CITY OF PICKERINGTON STP

**Re: Storm Water Inspection at City of Pickerington Sewage Treatment Plant  
Permit #4GC02584\*AG**

Figure 1 Entrance needs stabilization

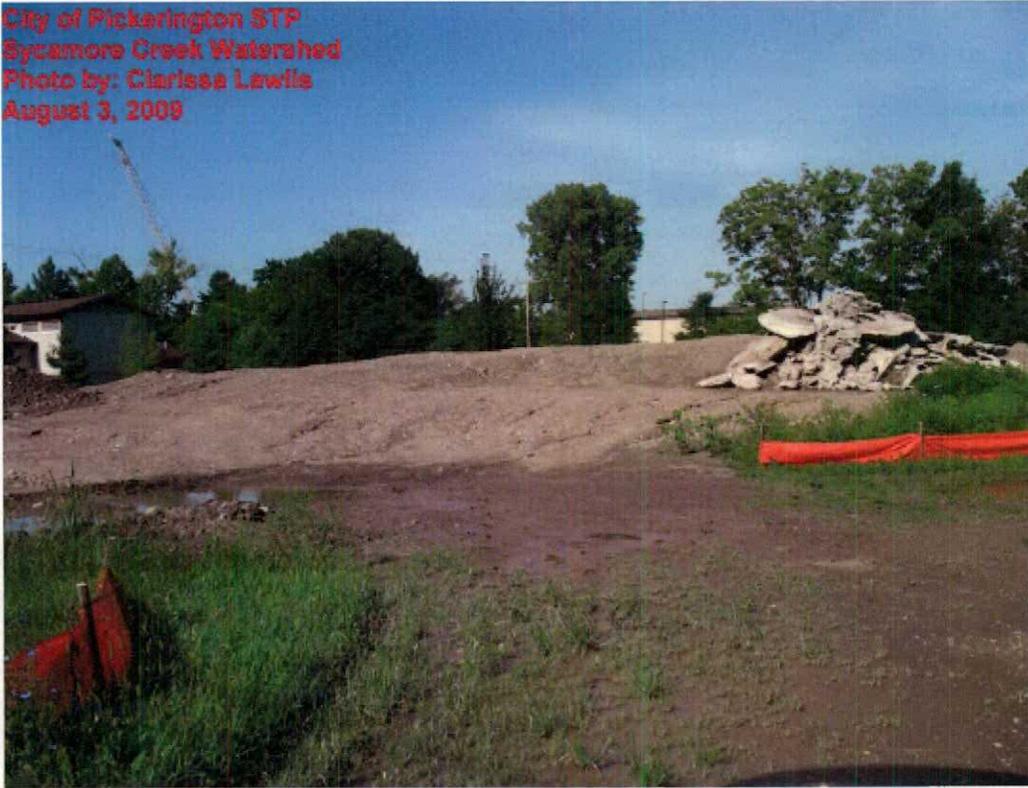
- The perimeter silt fence is functioning as intended. This general permit states that all sediment controls will be inspected and maintained every seven days or within 24 hours of a precipitation event equal to or greater than 0.5 inches. A log of inspection must be maintained on site for the agency to review.
- The north entrance of the site must be stabilized to prevent sediment runoff (See Figure 1).
